Land North of Toddington Lane

Response to WSCC Consultation Response

Planning Application LU/417/21/OUT

Document: Stage 1 Road Safety Audit

JOB TITLE		CLIENT	
Toddington Lane, Littlehampton		T & L Crawley No.2 LLP	
DRAWING TITLE			
Site Access Visibility Splays			
SCALE	DRAWN BY	DATE	DRAWING No
1:250@A3	BP	Oct21	23104-02
REVISION			
			A

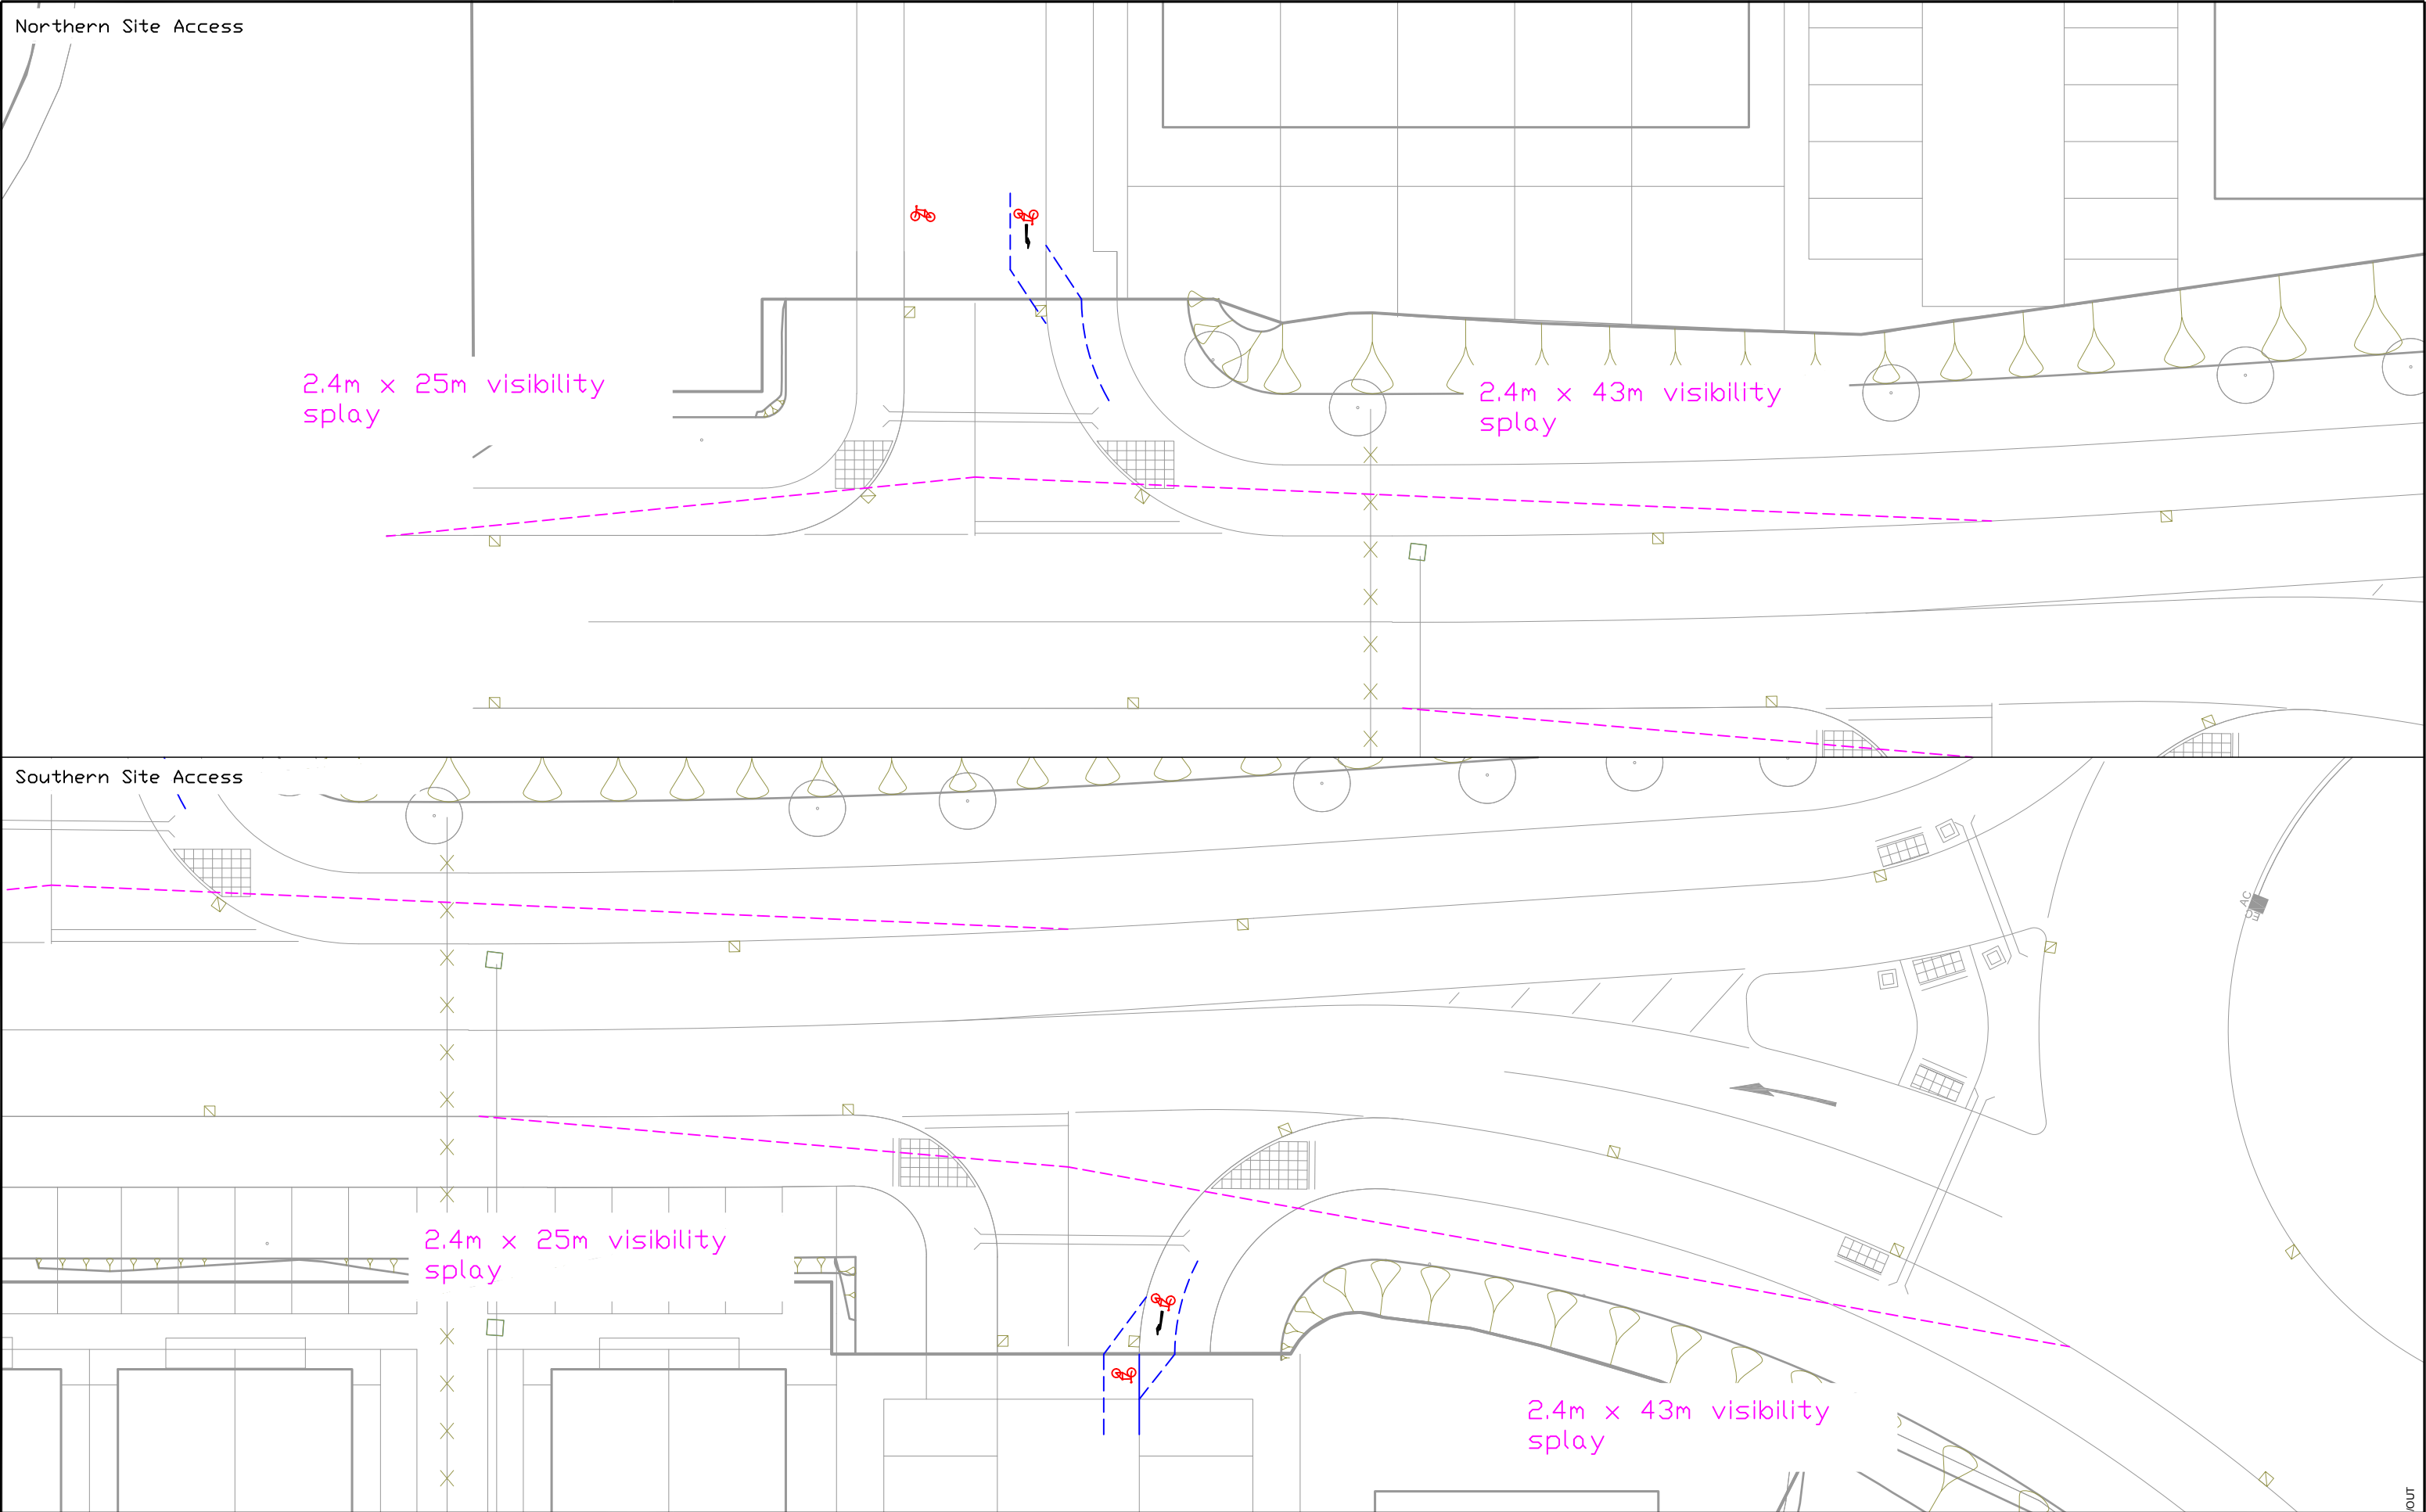
4. At the vehicular accesses themselves, a scheme showing additional lining and signing to provide safe linkage for those cyclists who route through the site on carriageway but wish to use the off-site footway/cycleway was produced. The lining comprises a

short section of segregated pedestrian and cyclist space before general use of the shared facility. These are shown on **DTA Drawing 23104-02a** which was submitted to the road safety auditor.

Turning to the vehicular access points, both show insufficient detail of how pedestrians and cyclists would enter and leave the sites. As seen from the submitted drawings, the spur road does provide for off-road shared foot and cycle access to the boundary of each site but what is not shown is how this would be continued into both land parcels. As such, the applicant should provide amended drawings showing how this would be achieved. Furthermore (and in addition to any alterations to the vehicular access points), the applicant should also consider the provision of foot and cycle linkages to and from the site closer to the roundabout junction as this could have the effect of providing more direct routes for non-motorised users.

Merging traffic passing on the offside may collide with a vehicle exiting the southern access

It is proposed to provide a two lane exit from the roundabout, merging just east of the new southern access. A large vehicle wishing to turn left into the southern access may stop or slow to allow a vehicle exiting the access to pull out first to make their left turn in easier. The audit team is concerned that a merging driver, especially a powered two-wheeler, may overtake and collide with the exiting vehicle.

The central hatching should be adjusted between the splitter island and the southern access to deter overtaking at this location.

Carriageway parking may lead to nose to tail or T-bone collisions

'Spur Road' and the new accesses do not have any parking restrictions indicated around the junctions. It is also noted that the roundabout design does not provide parking restrictions. This may lead to parking around the junctions and on 'Spur Road', restricting visibility from the accesses and leading to nose to tail or T-bone collisions.

Parking restrictions should be implemented on 'Spur Road'.

Restricted visibility may lead to nose to tail and T-bone collisions

Trees or vegetation are indicated within the visibility splay on 'Spur Road' to the east of the new southern access. This may obstruct visibility towards the roundabout for drivers exiting the southern access, leading to nose to tail and T-bone collisions.

The visibility splays should be kept clear of trees and vegetation, or a low level variety should be used.

Gullies at shared facility tie-ins may lead to cyclists losing control

The tie-in for cyclists between the shared surfaces on 'Spur Road' and the development internal roads is proposed to take the form of advisory cycle lane markings, both of which cross the kerbline at a gully location. Cyclists wheels crossing a gully may become trapped in the grating and lose control.

The dropped kerb for cyclists to access the 'Spur Road' shared facility should avoid the gullies. If this is not possible, cycle friendly gratings should be installed.

Gullies at shared facility tie-ins may lead to cyclists losing control

The tie-in for cyclists between the shared surfaces on 'Spur Road' and the development internal roads is proposed to take the form of advisory cycle lane markings. Should two opposing cyclists arrive at the dropped kerb at the same time, this may lead to confusion and cyclists losing control.

Signs and markings for cyclists travelling in both directions should be provided at the tie-in with the shared facility, indicating priority for cyclists joining the shared facility.

This element of the scheme has been designed and constructed by others. The recommendation is accepted.

The recommendation to implement parking restrictions at the junctions onto the Spur Road is accepted.

The recommendation is accepted.

The recommendation is accepted. The detail will be established at the detailed design stage.

The recommendation is accepted. The detail will be established at the detail design stage.
